Comment on the Proposed Drilling Plan for LANL Characterization Wells R-35a and R-35b as Sentry Monitoring Wells for Los Alamos County Drinking Water Well PM-3 by Robert H. Gilkeson, Registered Geologist  
- A report presented to the March 14, 2007 Meeting of the Northern New Mexico Citizen's Advisory Board.

Figure 1. Map Showing the Locations of LANL Characterization Wells R-8, R-11, R-13, R-28, and the Los Alamos County Drinking Water Wells O-4 and PM-3.

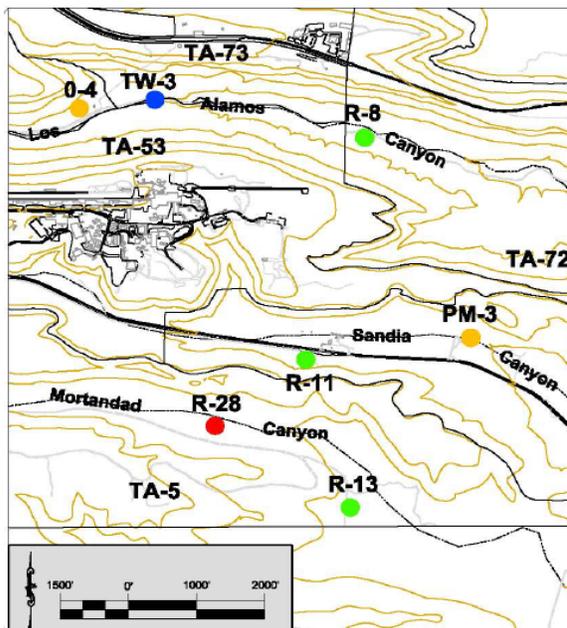
As shown on Figure 1, the property of the San Ildefonso Pueblo is ¼-mile to the south of well R-28. LANL well R-13 does not establish the lateral dimensions of the hexavalent chromium plume because the top of the well screen is 125 feet below the water table, and below confining beds of clayey sediments. It is very probable that the chromium plume is present in the highly permeable aquifer strata that are present at a shallow depth below the water table at the location of well R-13.

It is very probable that the chromium plume is contaminating the regional groundwater resource that is the property of the San Ildefonso Pueblo. It is also possible that the level of hexavalent chromium contamination is greater on the Pueblo property than is measured at well R-28. There is an immediate need to install a reliable monitoring well on the property of the San Ildefonso Pueblo at a location south of well R-28.

**LANL characterization well R-8.** Well R-8 is one example of the failure of the attempt to drill an open borehole with the same open-hole methods proposed for the two R-35 wells. The location of Well R-8 north of drinking water well PM-3 is displayed on Figure 1.
